HOMESTEAD NORTH AT STERLING RANCH

EARLY GRADING AND EROSION CONTROL PLANS

PCD-ENGINEERING REVIEW COMMENTS
IN BLUE BOXES WITH BLUE TEXT

PCD FILING NO.: SP-20-008

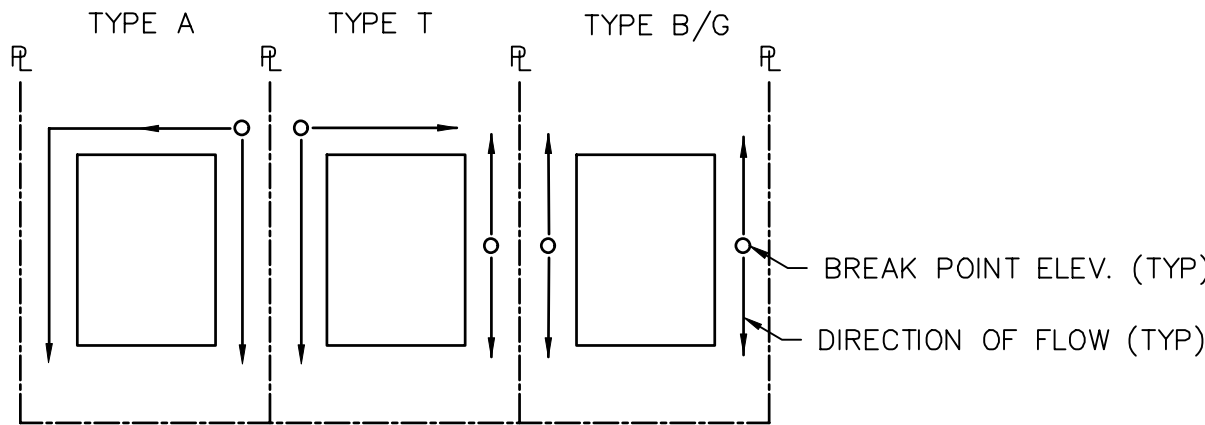
Provide erosion protection to bottom of channel

JR Response: Added protection to the bottom of the channel

SHEET 10 OF 10		HOMESTEAD NORTH AT STERLING RANCH				H-SCALE	N/A	No.	REVISION	BY	DATE
		DETAIL				V-SCALE	N/A				
						DATE	06/30/21				
						DESIGNED BY	XXX				
						DRAWN BY	XXX				
						CHECKED BY					
JOB NO.		25188.00

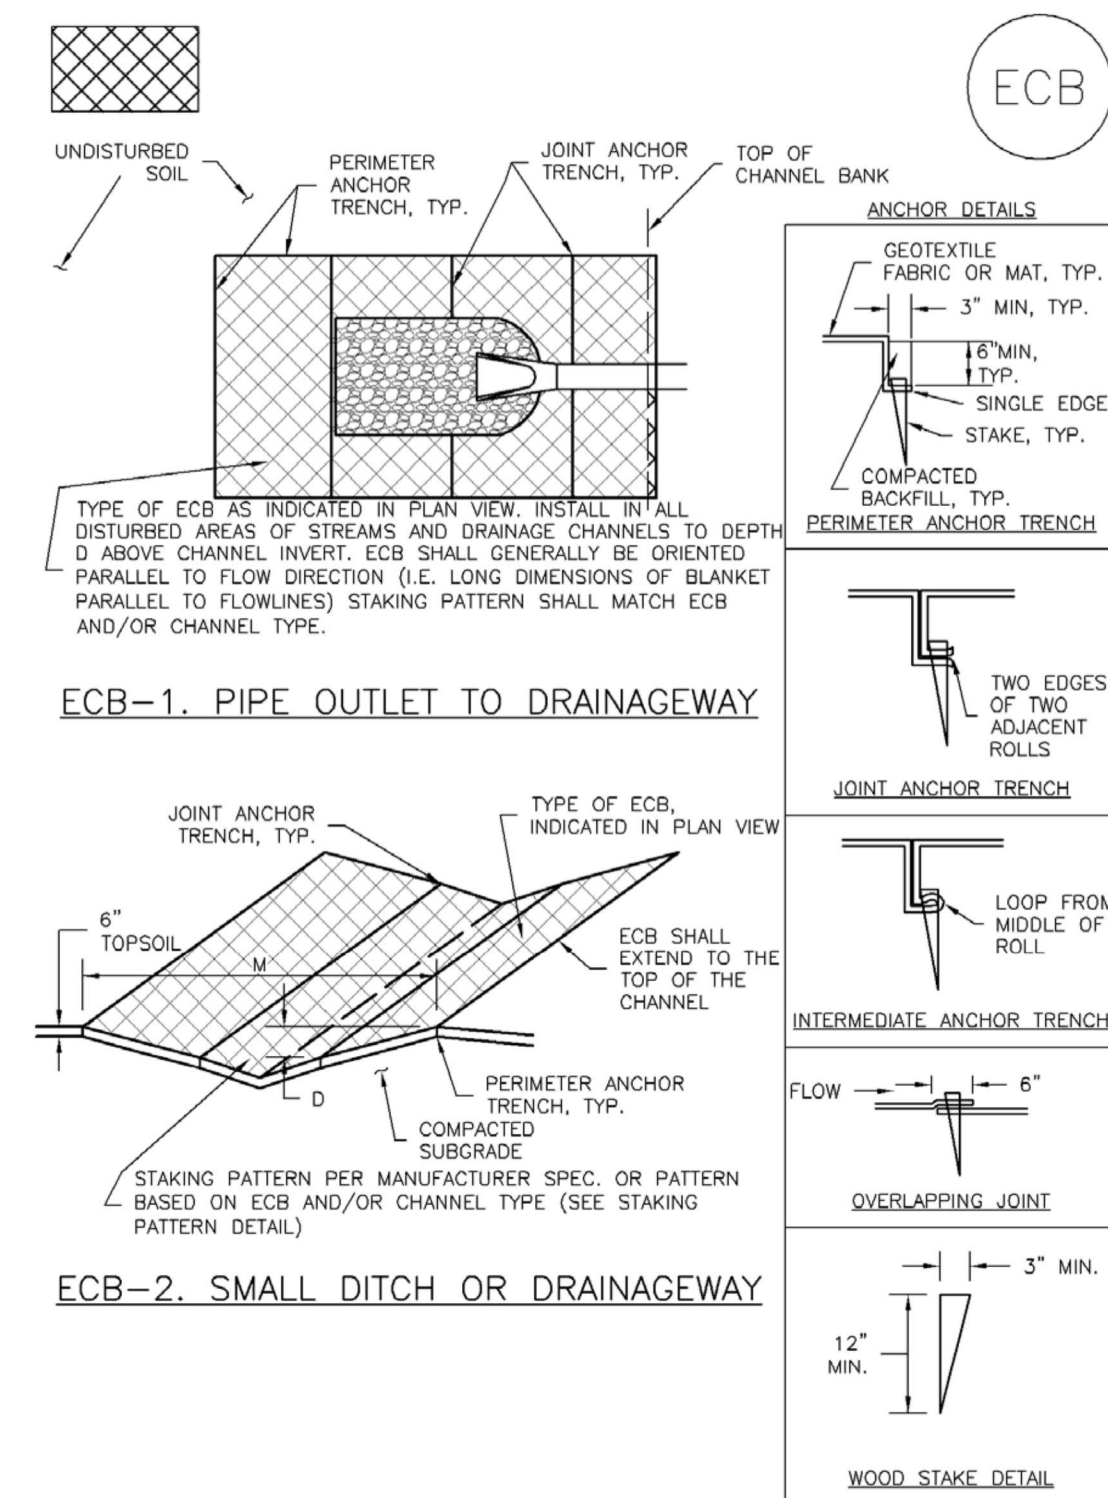
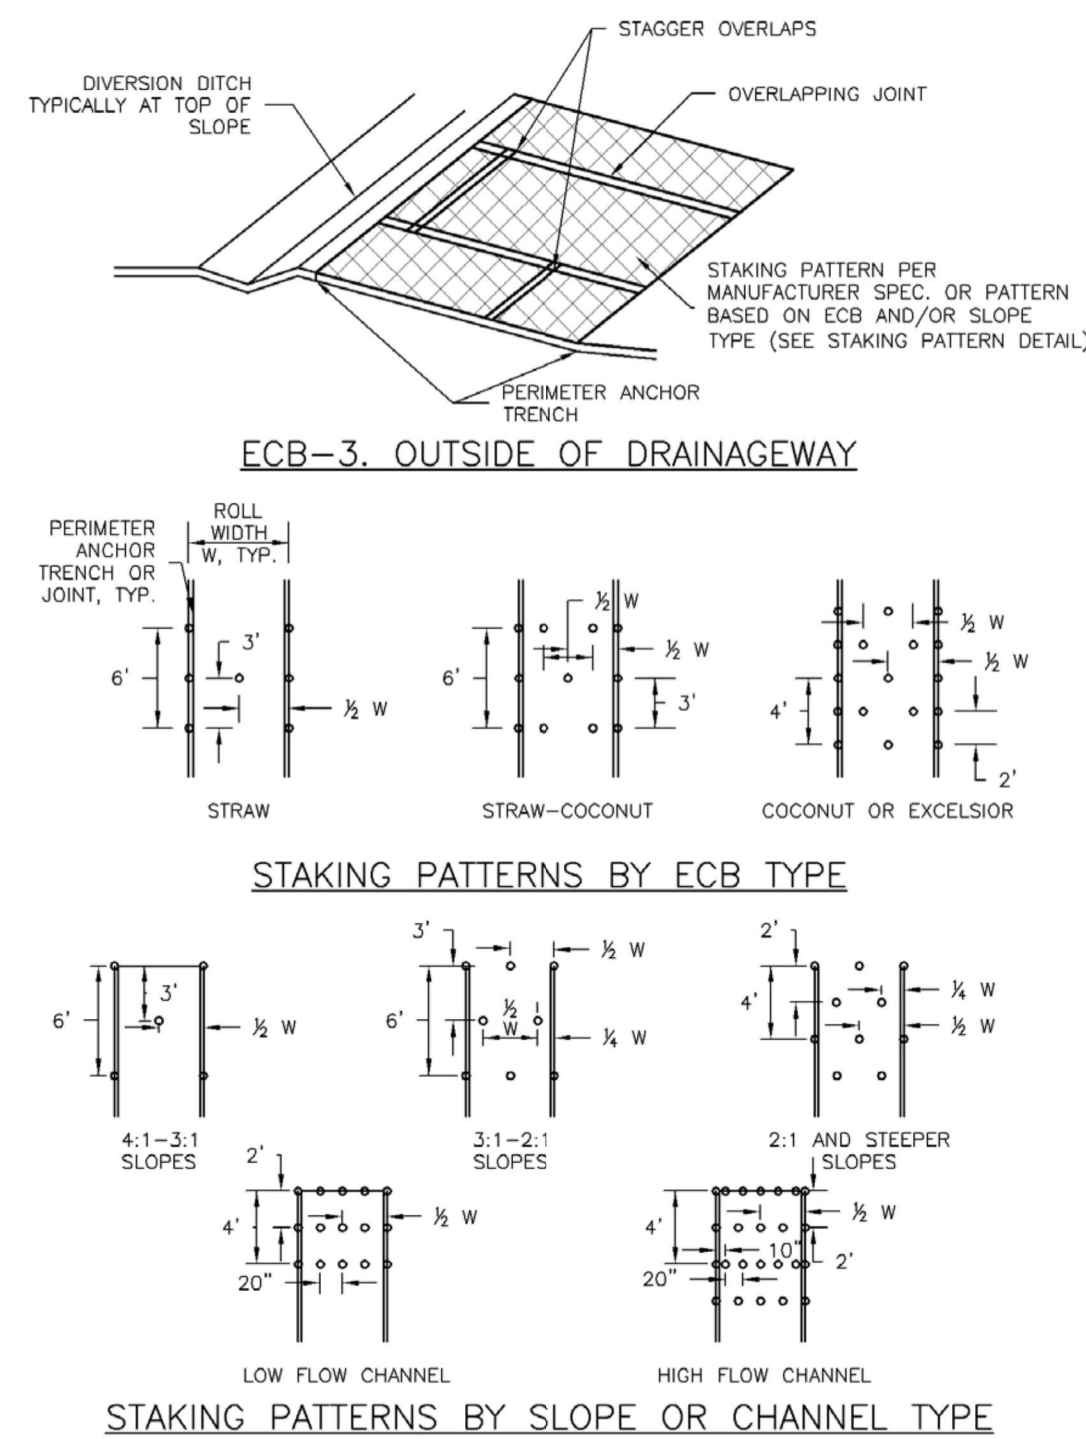
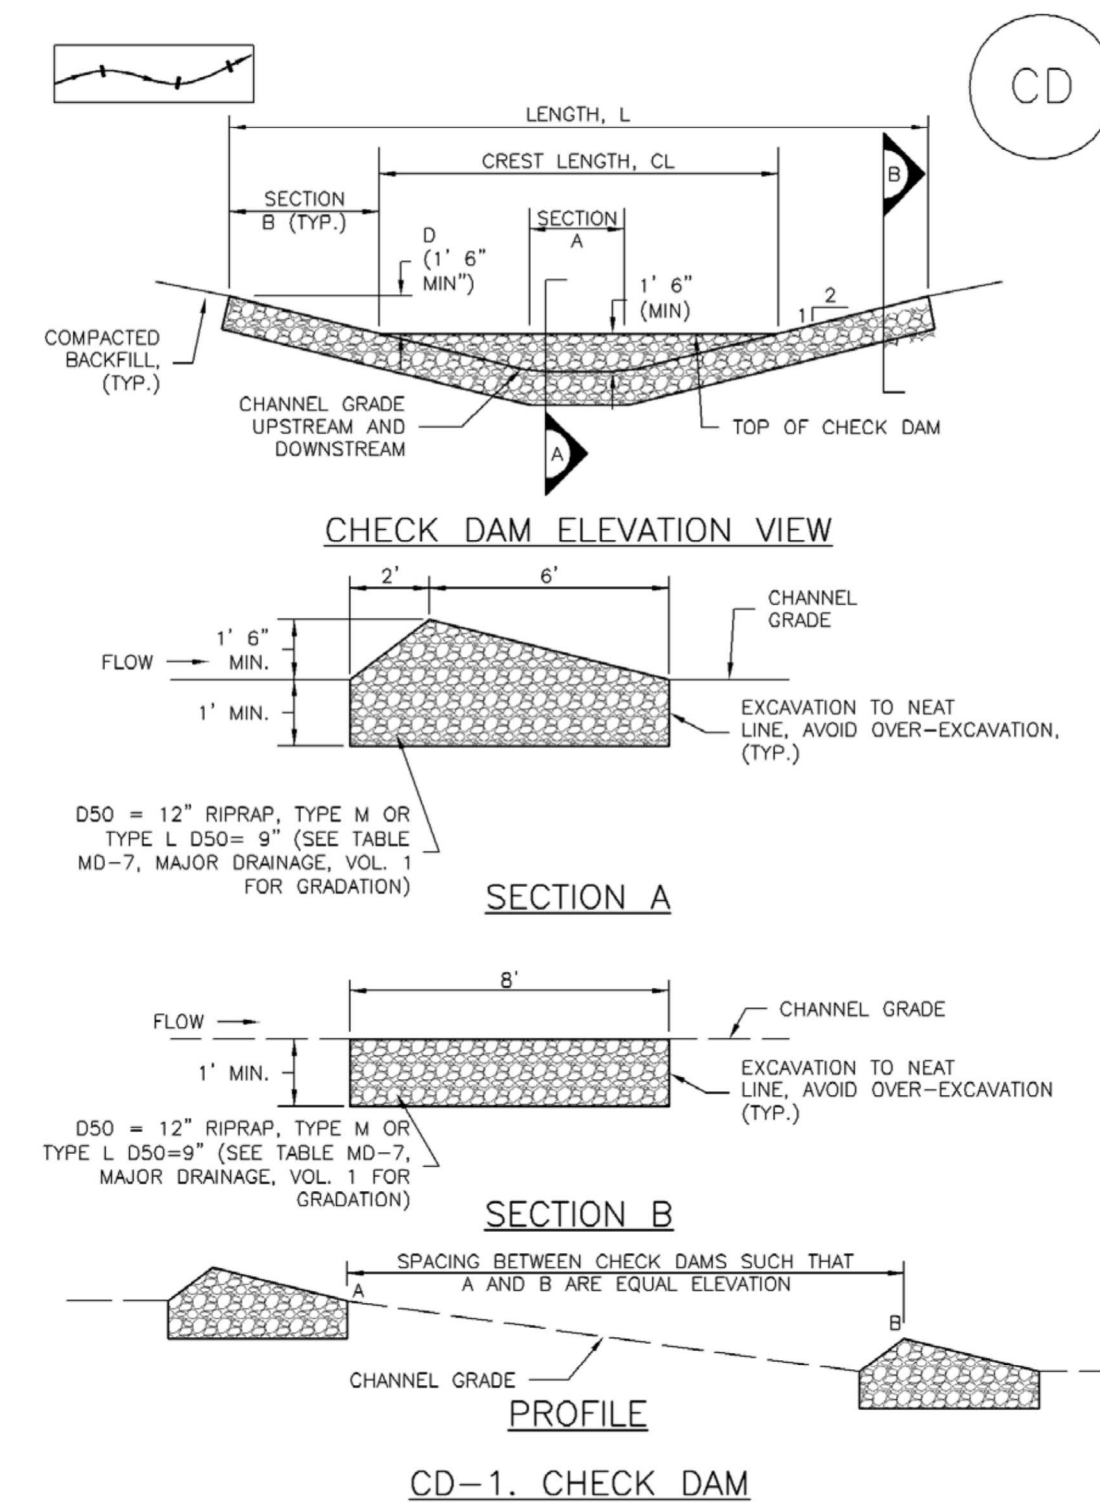
Rock socks were added to plans for V3, so also add a detail for RS's on this sheet.

And still need a detail for rough cut street control.

Examples of acceptable details for each are provided:

JR Response: Details added
